Manual Supplement

Manual Title:	Service Manual PM3370B/8xB/9xB	Supplement Issue:	4
Part Number:	4822 872 05372	Part Number:	4822 872 08566
Print Date:	15-June-1997	Issue Date:	19-April-2002
Revision/Date:	-/-	Page Count	15

This supplement contains information necessary to ensure the accuracy of the above Service Manual. The following items have been added:

Figure 8. Digitizer A8 – Layout of Mini-PCB with ADC's.

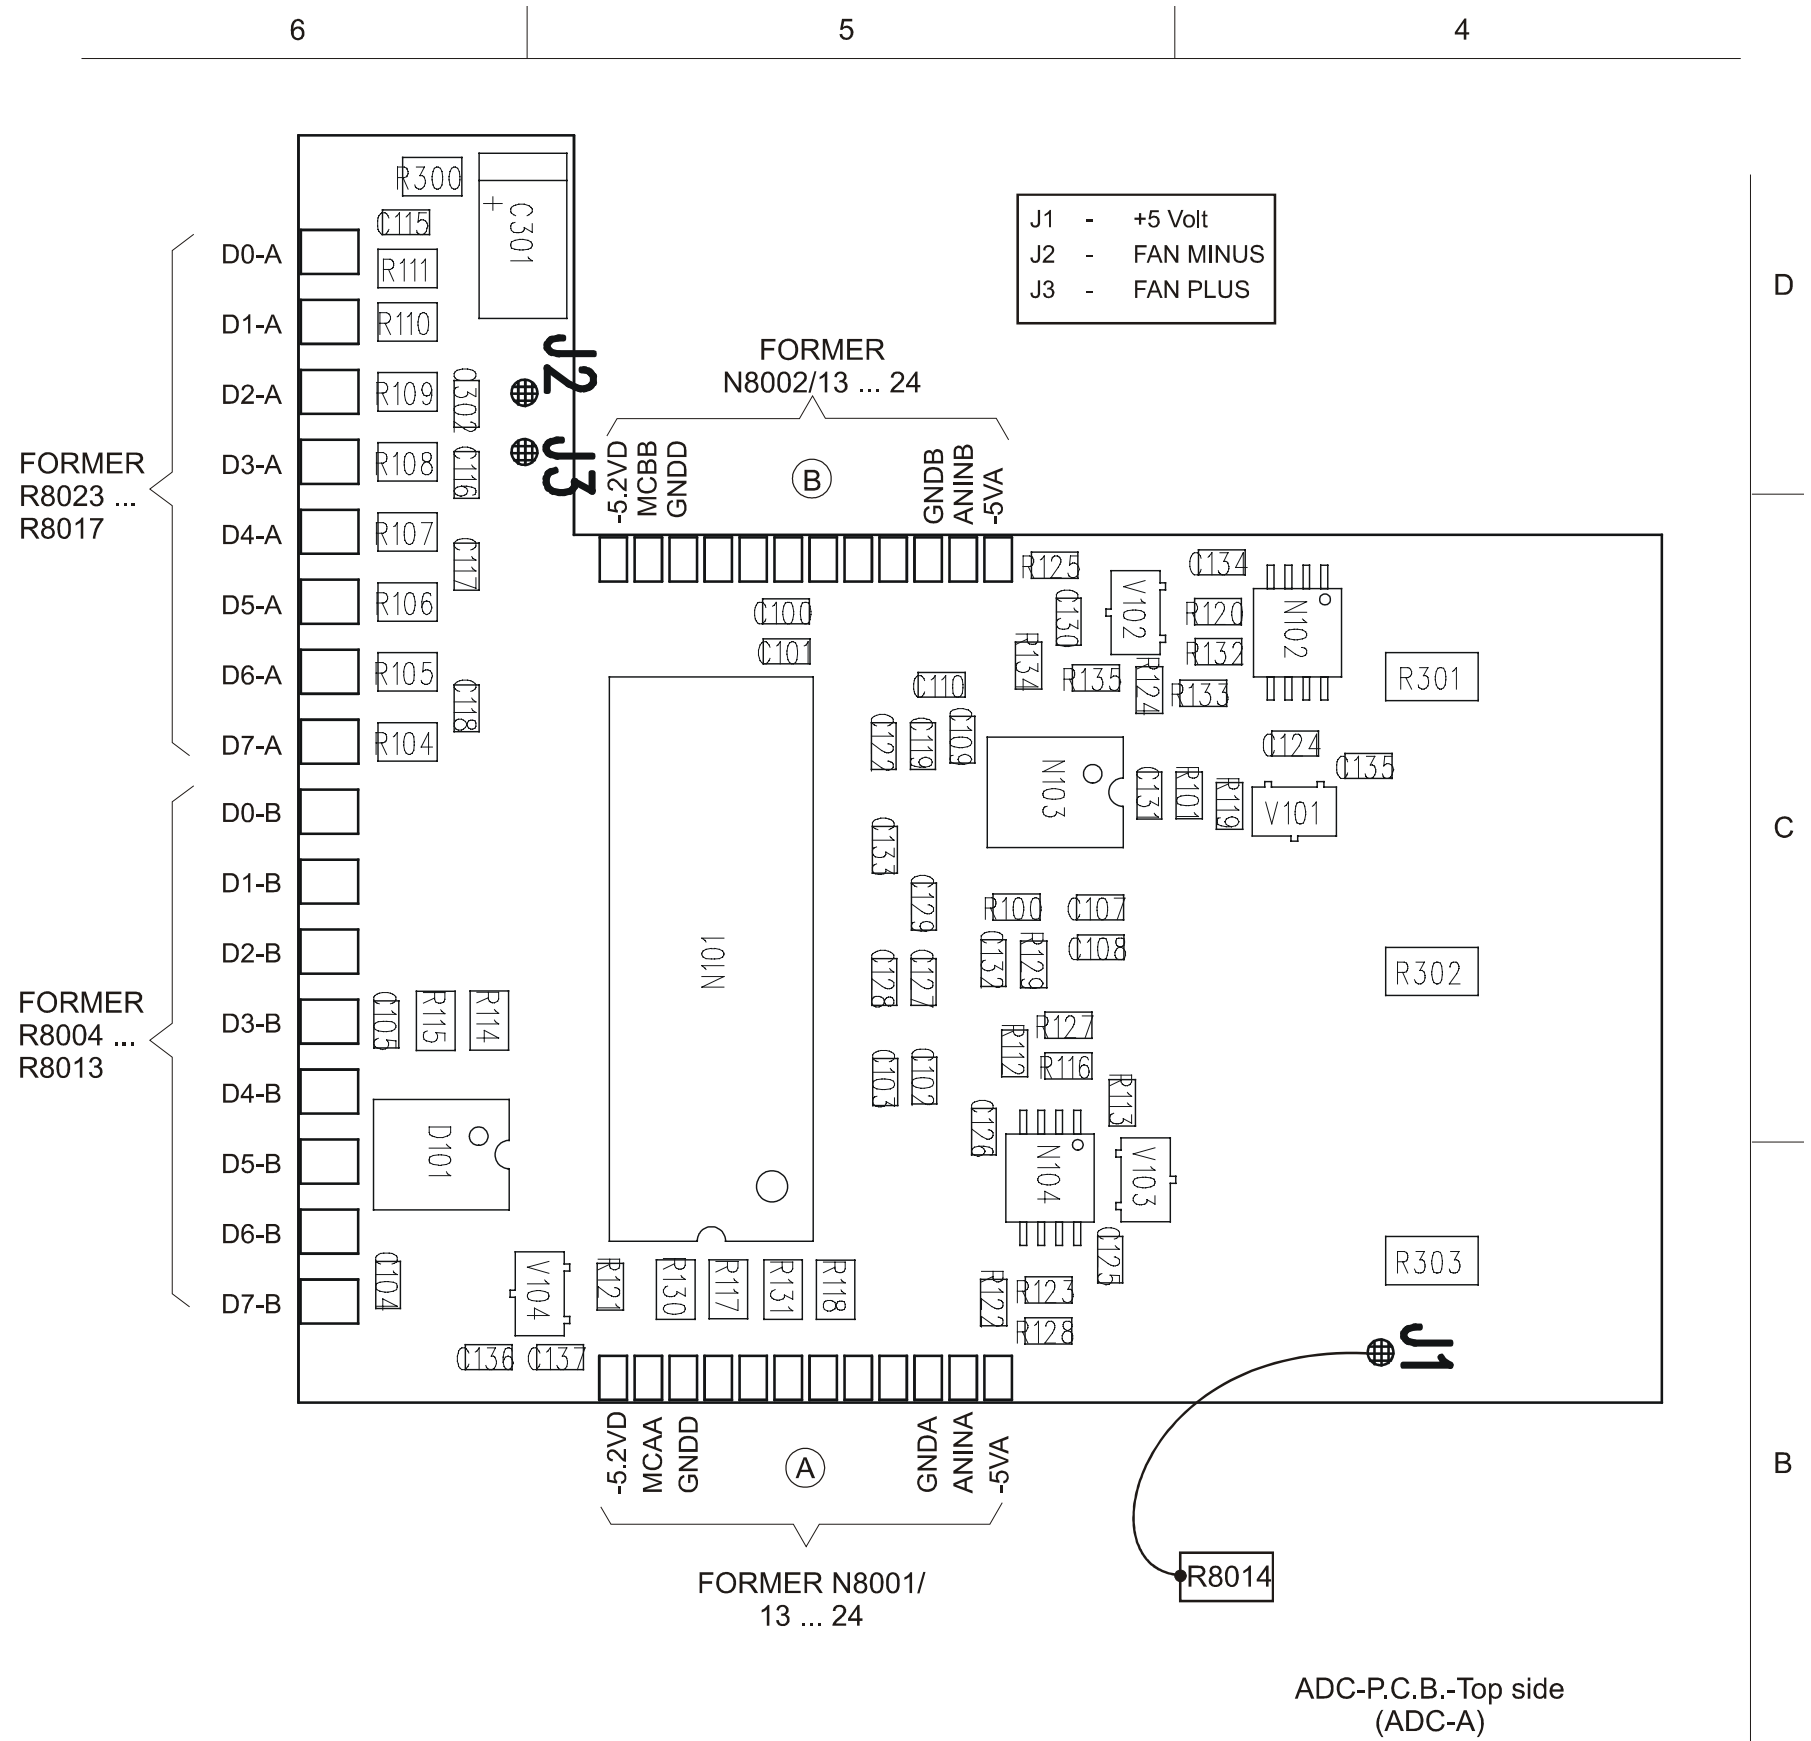
The ADC's N8001 and N8002 of the type OQ0239 are obsolete. Starting with serial number DM 804xxx, the ADC's are replaced by a L-shaped mini-PCB with 2 ADC's of a new type, auxiliary components, and an additional small 5 V fan. The mini-PCB is connected to the small components side of digitizer A8 with 40 pins and has components on both sides: the ADC-A section is on the 'visible' side and ADC-B is on the side that faces A8. The mini-PCB is designed so that its connection pins align with the existing A8 PCB layout. Figure 8 shows the visible side of the mini-PCB. The connection pins align with the former N8002/pin 13 .. 24 (ADC-B input/supply), the former N8001/pin 13 .. 24 (ADC-A input/supply), and the former termination resistors of the ADC outputs D0-A .. D7-A and D0-B .. D7-B. The mini-PCB is used in a limited number of oscilloscopes.

Repair method: in case of a defective mini-PCB, you have to remove it and restore the situation such as indicated on page 5.8-29 and 5.8-30 of the Service Manual. For this proceed as follows:

- Remove the mini-PCB by cutting all interconnection pins and remove the remains of the pins from the digitizer PCB.
- Install N8001, N8002 (OQ0239, PN 5322 209 12509) and install a heatsink (PN 4022 242 13701) on top of each IC. How to mount the heatsink is shown on page 5.8-30.
- Add on the large component side R8555, R8556, R8557, R8558 (42.2 ohm, PN 4822 111 91887).
- Add on the small component side R8004, R8006, R8007, R8008, R8009, R8011, R8012, R8013, R8016, R8017, R8018, R8019, R8021, R8022, R8023, R8024 (1 kilo-ohm, PN 4822 051 10102).
- Add on the large component side C8127, C8129, C8132, C8137 (22 nF, 5322 122 32654).
- Add on the small component side C8124, C8126, C8128, C8131, C8133, C8134, C8136, C8194, (22 nF, 5322 122 32654).
